RED EYE INVESTMENTS SUBDIVISION

APPLICATION NUMBER 22 DATE August 16, 2007

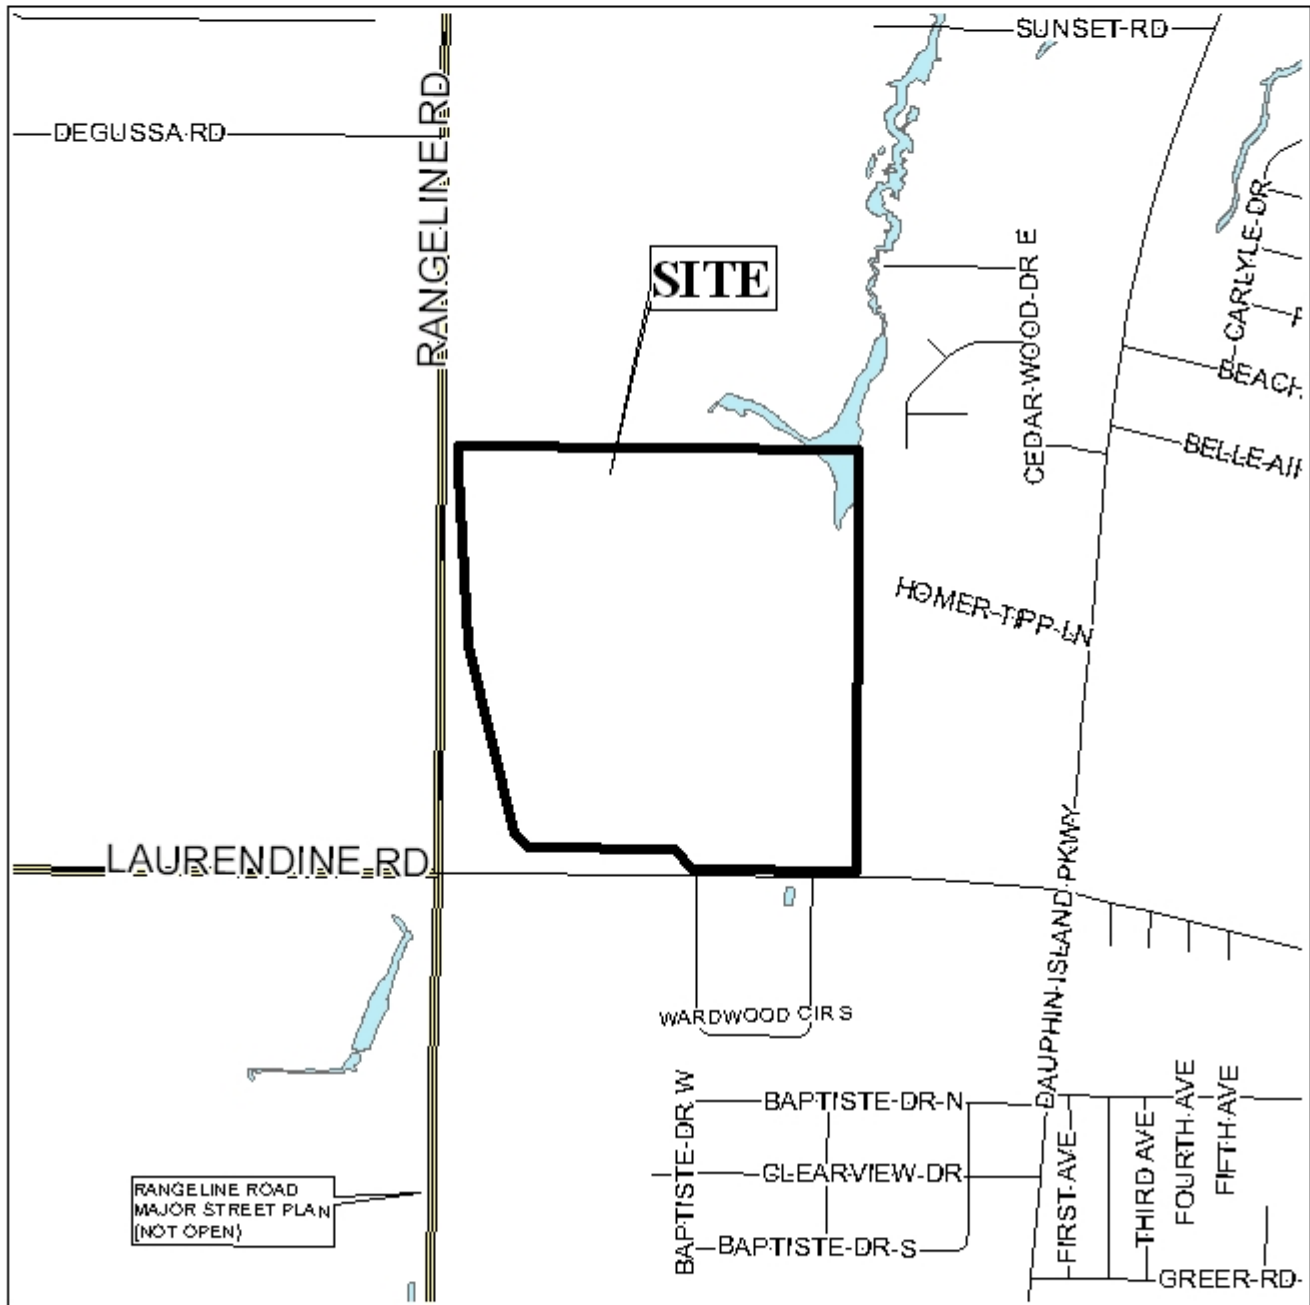
The plat illustrates the proposed 3-lot, 77.0± acre subdivision which is located on the Northeast corner of Rangeline Road and Laurendine Road. The applicant states that the subdivision is served by public water and individual septic facilities.

The site fronts Rangeline Road, which is shown as a major street and classified as a limited access thoroughfare on the Major Street component of the Comprehensive Plan; and as such, requires a minimum right-of-way of 300-feet. Laurendine Road is illustrated as having a minimum of 80-feet right-of-way, which meets the minimum requirements of a minor street. The plat does not indicate the existing right-of-way width along the site. Therefore, dedication sufficient to provide a minimum of 150-feet from centerline should be required. However, since ALDOT has plans to construct a service road along this section of Rangeline Road, the development should be allowed three curb cuts, to Rangeline Road and three curb cuts to Laurendine Road with the, size and location curb cuts should be approved by County Engineering and ALDOT.

It should be noted due to the number of lots proposed; location of the curb cuts could be positioned as not to interfere with the proposed construction of the service road. Therefore, the developer should connect to the service road(s) when constructed and eliminate access to Rangeline Road and Laurendine Road. The letter submitted in the previous subdivision should be submitted again to verify ALDOT and the County position on the service road.

A portion of the site may contain wetlands. The possible presence of wetlands indicates that the area may be environmentally sensitive; therefore, the approval of all applicable federal, state and local agencies would be required prior to the issuance of any permits or land disturbance activities.

Due to the limited width of each lot, each lot should be restricted to one curb-cut, with the size, design and location to be approved by the Mobile County Engineering Department.

This site is located in Mobile County, thus a note should be placed on the Final Plat stating that any lots which are developed commercially and adjoin residentially developed property must provide a buffer, in compliance with Section V.A.7 of the Subdivision Regulations.

Finally, while the site is in Mobile County, it will have to comply with the City of Mobile storm water and flood control ordinances. A note should be placed on the final plat stating that the development will be designed to comply with the storm water detention and drainage facility requirements of the City of Mobile storm water and flood control ordinances, and requiring submission of certification from a licensed engineer certifying that the design complies with the storm water detention and drainage facility requirements of the City of Mobile storm water and flood control ordinances prior to the signing of the final plat. Certification is to be submitted to the Planning Section of Urban Development and County Engineering. If detention facilities will be required, the plat should be revised to depict common areas that will be used for detention, if required.

Based on the preceding, the application is recommended for Tentative Approval, subject to the following conditions:

- 1) the placement of a note on the Final Plat stating that the development be limited to three curb cuts to Rangeline Road and three curb cuts to Laurendine Road, with the location, size and design to be approved by County Engineering and ALDOT;

- 2) revision of the plat to label each lot with its size in square feet, or placement of a table on the plat with the same information;
- 3) the placement of a note on the Final Plat stating that the developer must connect to the service road(s) when constructed and eliminate direct access to Rangeline Road and Laurendine Road;

- 4) placement of a note on the final plat stating that the development will be designed to comply with the storm water detention and drainage facility requirements of the City of Mobile storm water and flood control ordinances, and requiring submission of certification from a licensed engineer certifying that the design complies with the storm water detention and drainage facility requirements of the City of Mobile storm water and flood control ordinances prior to the signing of the final plat. Certification is to be submitted to the Planning Section of Urban Development and County Engineering;

- 5) revision of the plat to depict and label common area detention facilities, if required; and
- 6) the provision of a 20-foot undisturbed buffer zone along the East property line.
